Docket Number:	09-AFC-08C
Project Title:	Genesis Solar Energy Project
TN #:	212350
Document Title:	Petition to Amend for Ammonia tanks and gas cylinder storage
Description:	in Units 1 and 2 and Gas Cylinder Storage Area in Common Area
Filer:	Eric Veerkamp
Organization:	Genesis Solar, LLC
Submitter Role:	Applicant
Submission Date:	7/18/2016 4:39:29 PM
Docketed Date:	7/18/2016

Petition to Amend

July 2016

PLOT PLAN UNIT 1
POWER BLOCK

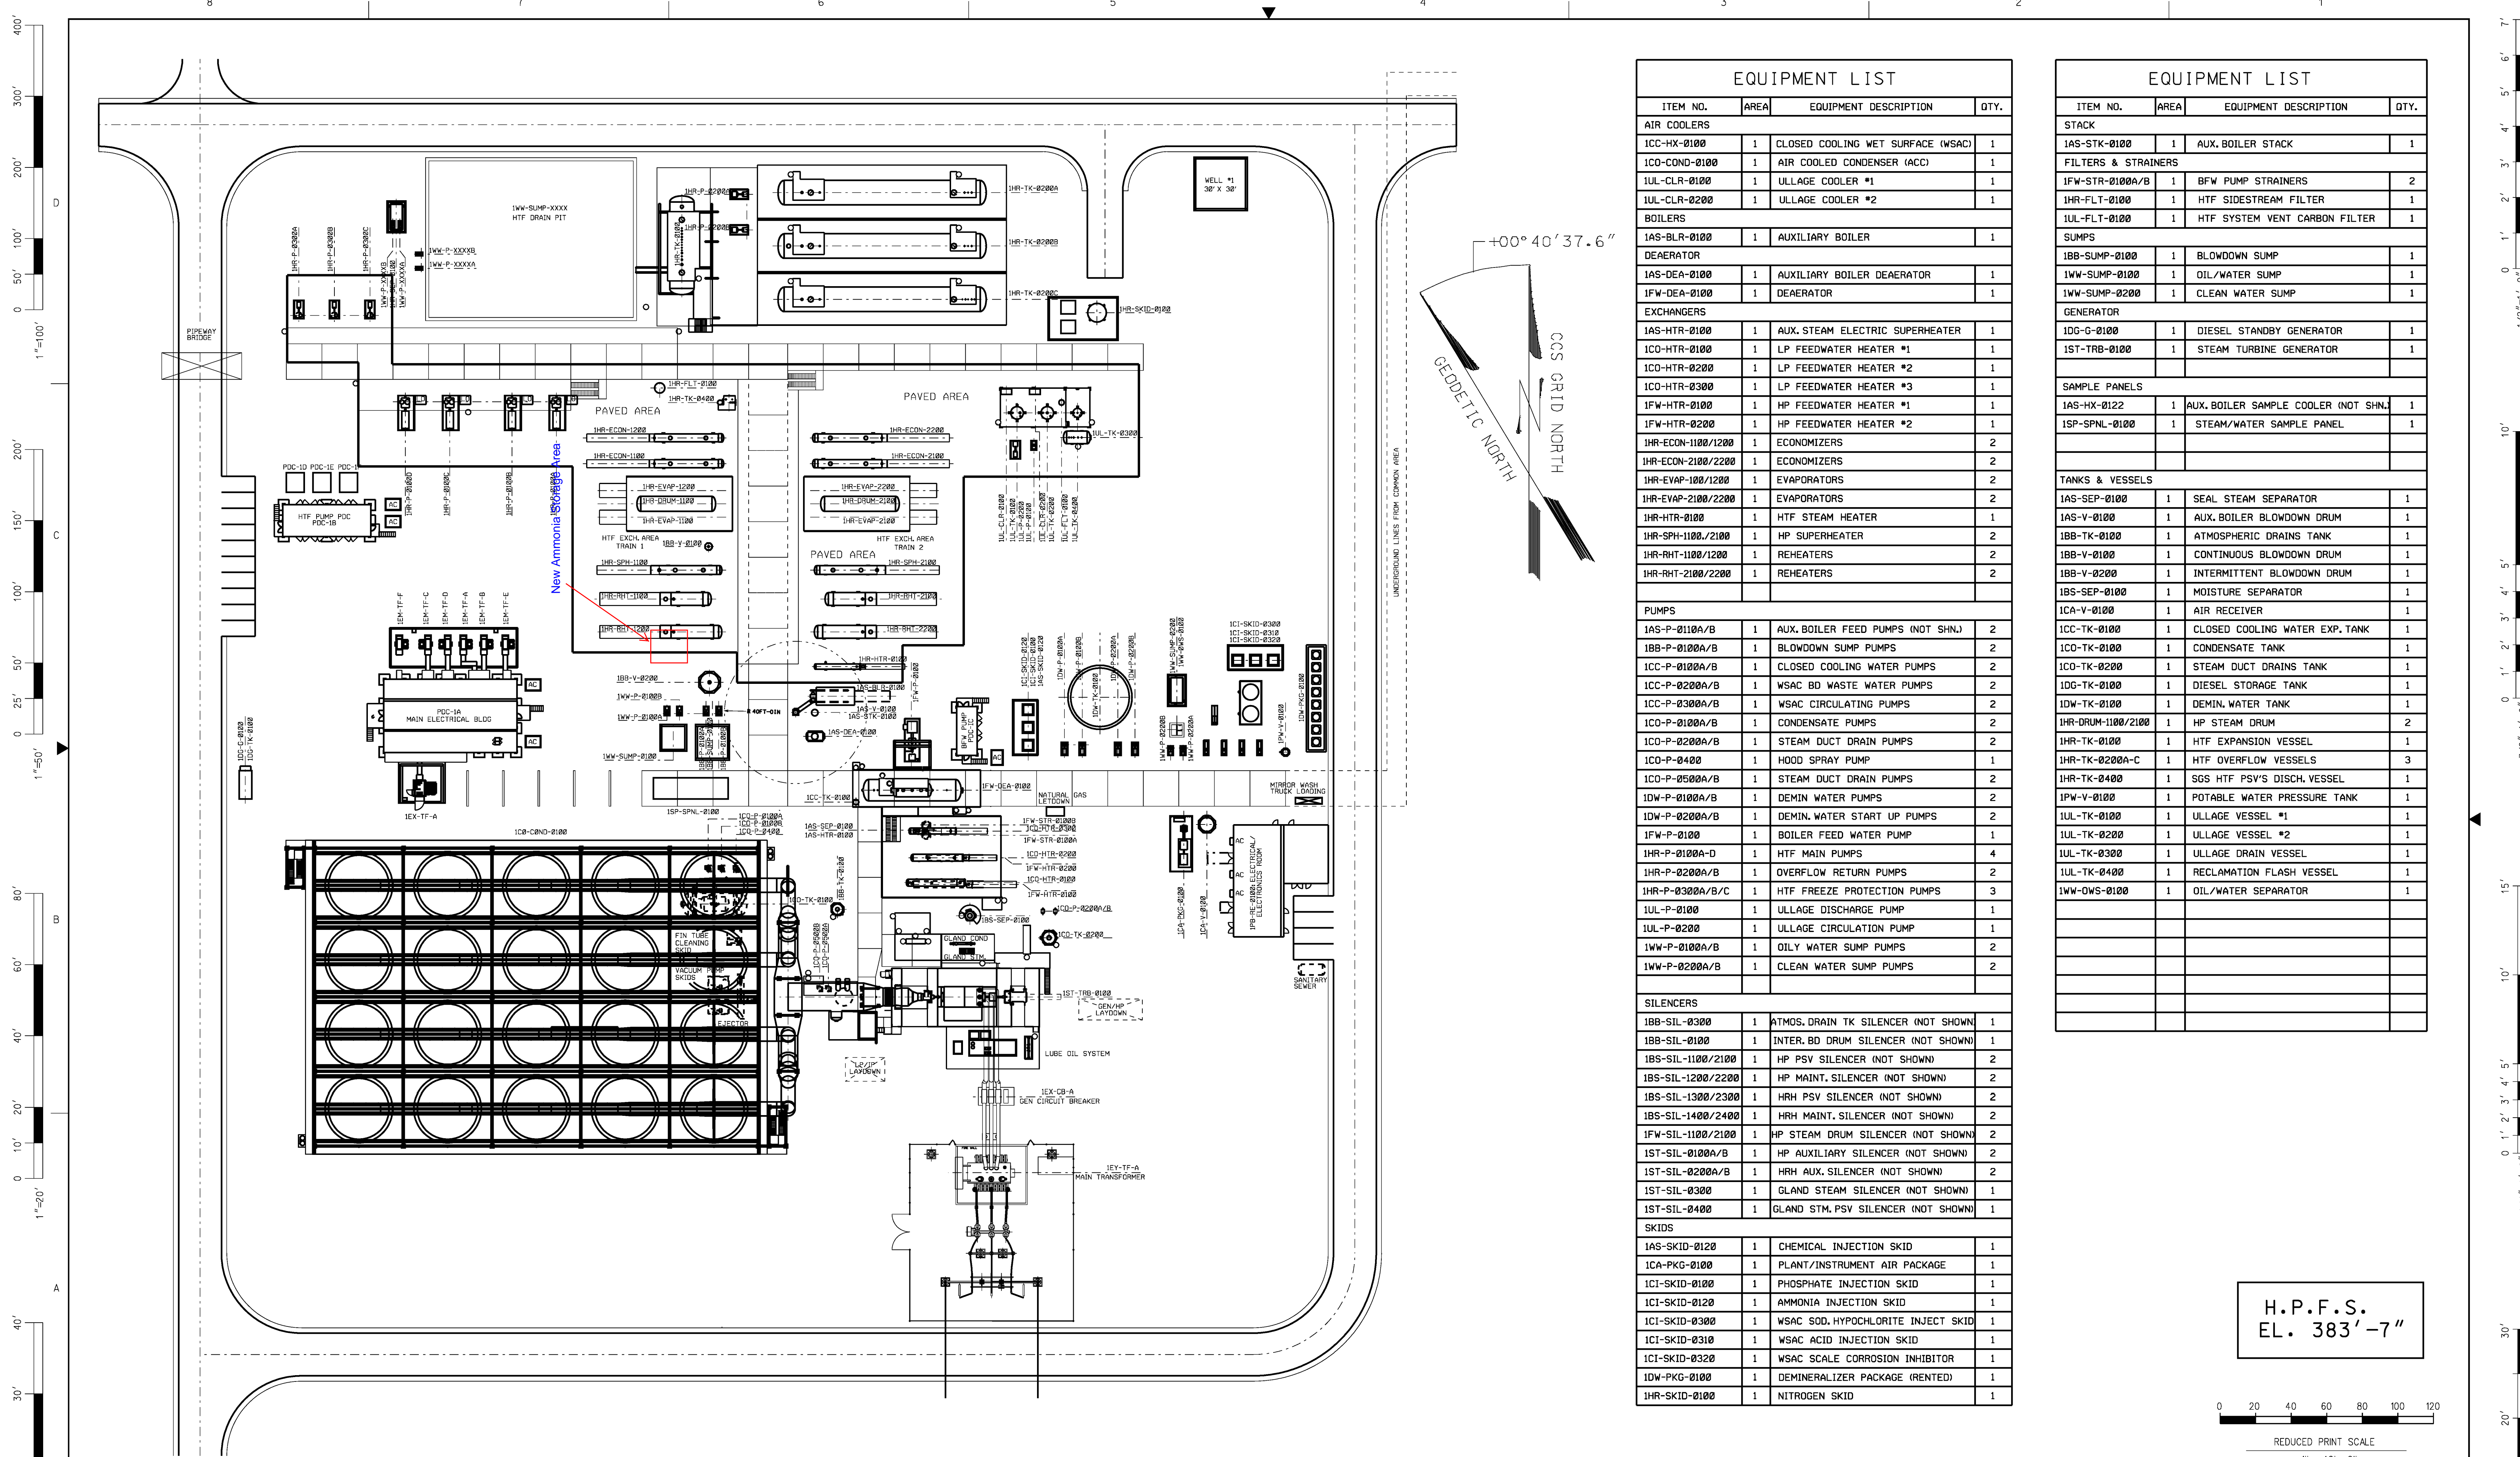
Consist of a double walled, self-contained, above ground tank with a 3100 gallon capacity filled to 2800 gallons. A concrete pad and a shade cove will be installed. (See Drawings)

Extend Cover North
